Re: Des Moines Independent Community School District  
Floor Finish Replacement Package #1 – Bid Bo: 8750

## ADDENDUM #1

December 10<sup>th</sup>, 2021

ASD 01

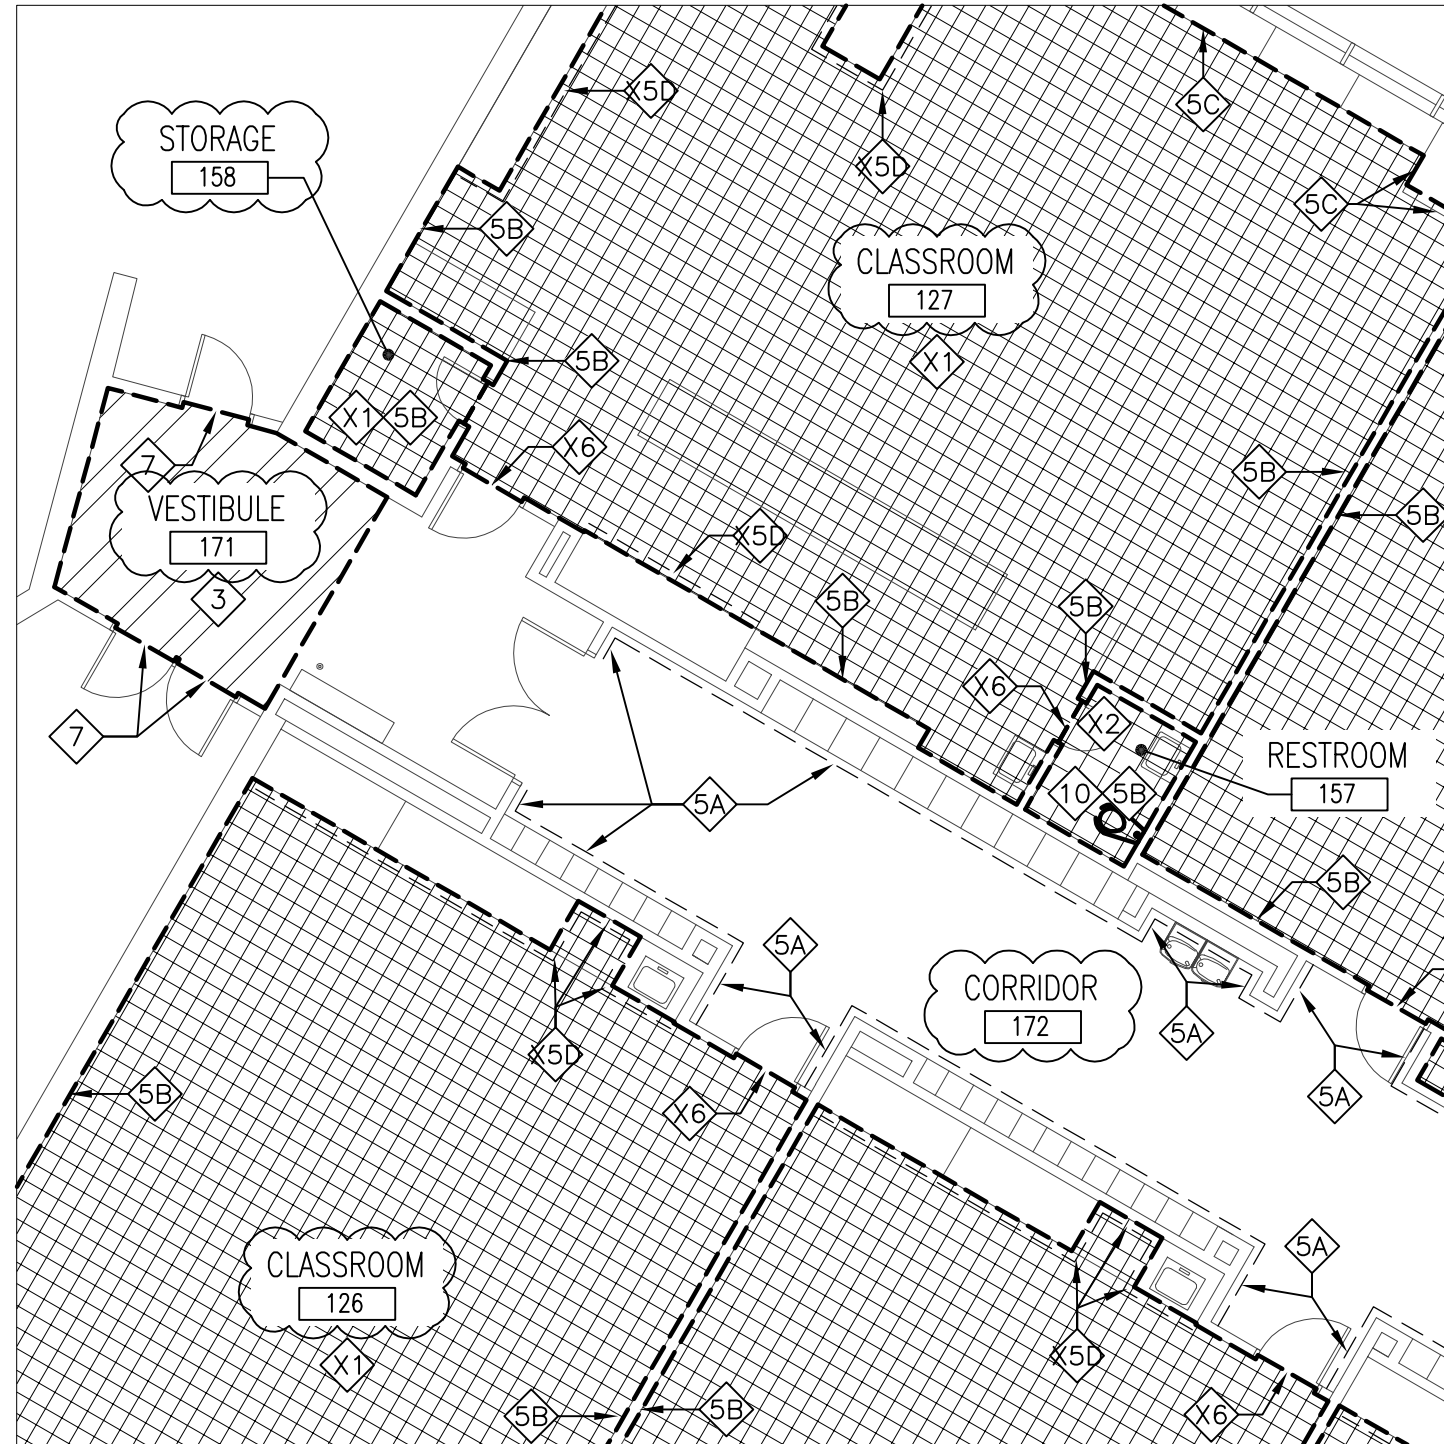
- Item #A1: **CLARIFICATION – PRINT ERROR – ROOM NAME/NUMBER (WRIGHT)**  
There appears to be a printer error which caused several of the room names and room numbers to be blacked-out on sheets AD1.1, AD1.2, A1.1, and A1.2 (WRIGHT). Corrections & clarifications are provided.

PRINT ERROR - ROOM NAME/NUMBER  
UPDATE DEMO FLOORPLAN ON SHEET AD1.1

PRINT ERROR - ROOM NAME/NUMBER  
UPDATE DEMO FLOORPLAN ON SHEET AD1.2

ASD 02

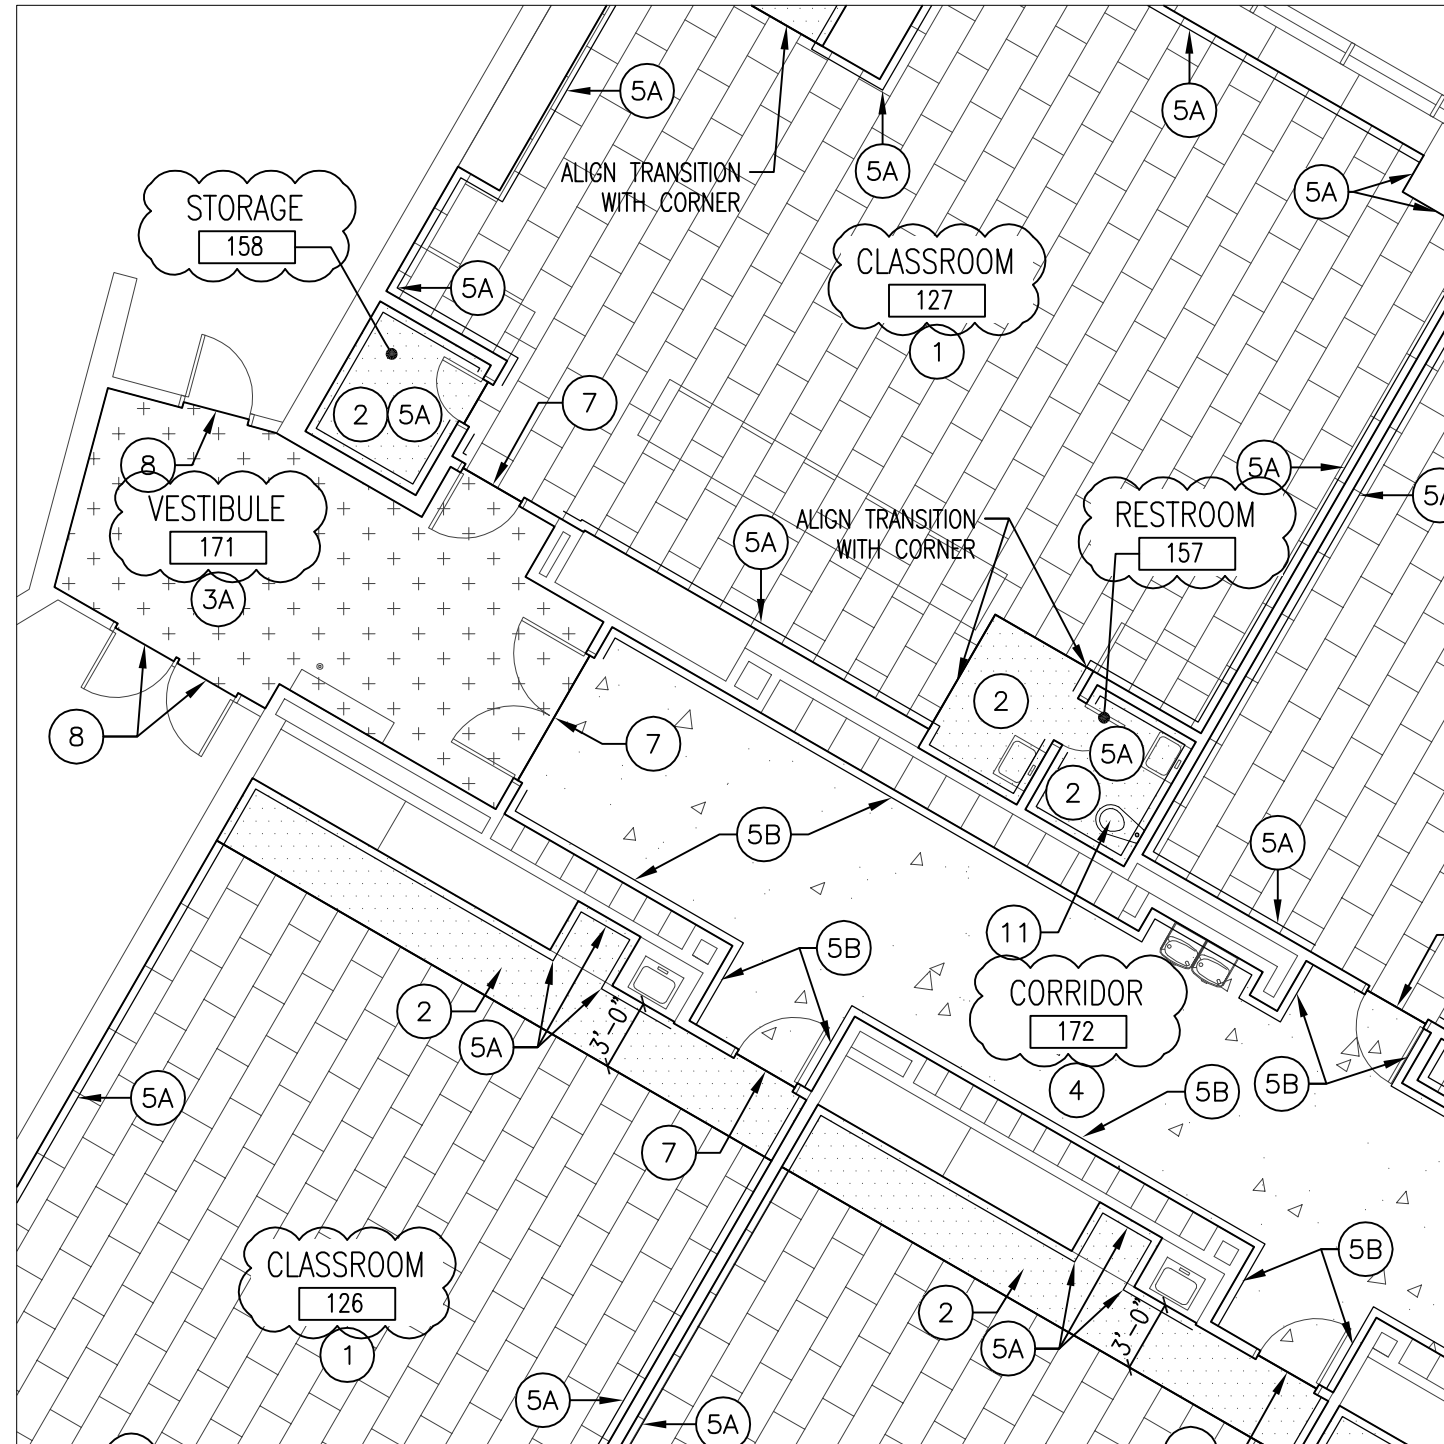
PRINT ERROR - ROOM NAME/NUMBER  
UPDATE FLOORPLAN ON SHEET A1.1

PRINT ERROR - ROOM NAME/NUMBER  
UPDATE FLOORPLAN ON SHEET A1.2
